City of West Linn
PRE-APPLICATION CONFERENCE MEETING
Notes
May 16, 2013

SUBJECT: Class I Design Review, Water Resource Area permit, Class II Variance, and permit to Enlarge/Alter a Non-Conforming Structure for moving ingress/egress points, paving, and installing stormwater swale, at Dan Davis Recycling Center at 4001 Willamette Falls Drive. Variance is for curb cut width.

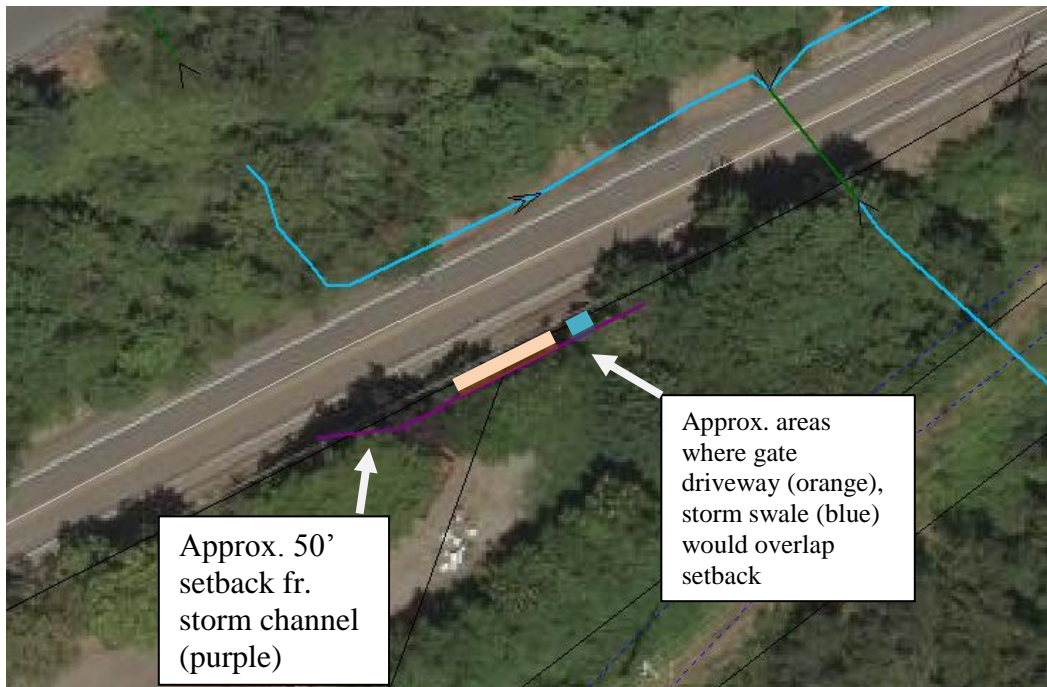
There is a storm channel across Willamette Falls Drive that is covered by the provisions of Chapter 32, per 32.020(C), as it is an open channel on the Surface Water Management Plan that is a roadside swale in a non-residential area. Therefore any development proposed within 50 feet of this channel requires the Water Resource Area permit, if the development is proposed where no paving or structures exist currently. Per both City GIS (insert below) and staff measurements, the only development proposed that would overlap with this 50 foot setback (in areas where there is not already development) is in the northeast corner of the site. This overlap occurs where areas that currently have trees and vegetation would become developed with the north ends of the stormwater treatment swale and the driveway serving the new entrance gate. See these approximate overlap areas on the aerial photo insert below.

In the approval criteria for the Water Resource Area (WRA) permit, 32.050(F) allows driveways to be built in these transition area setbacks if no other practicable alternative exists, so the applicant should demonstrate that no practicable alternative exists, or not propose to move this entrance/exit point of the site. Also in the approval criteria for the Water Resource Area permit 32.050(M) allows stormwater treatment facilities to encroach up to 25 feet into the transition area setback as long as an equal sized area is added to the transition area on site. The proposed swale would definitely encroach less than 25 feet into the setback, so this should be fine as long as the appropriate mitigation

and revegetation are done. Like the driveway, the storm swale could be alternately proposed only in areas that are not in the Water Resource Area transition area. If both these changes are made to the proposal the Water Resource Area permit would not be needed.
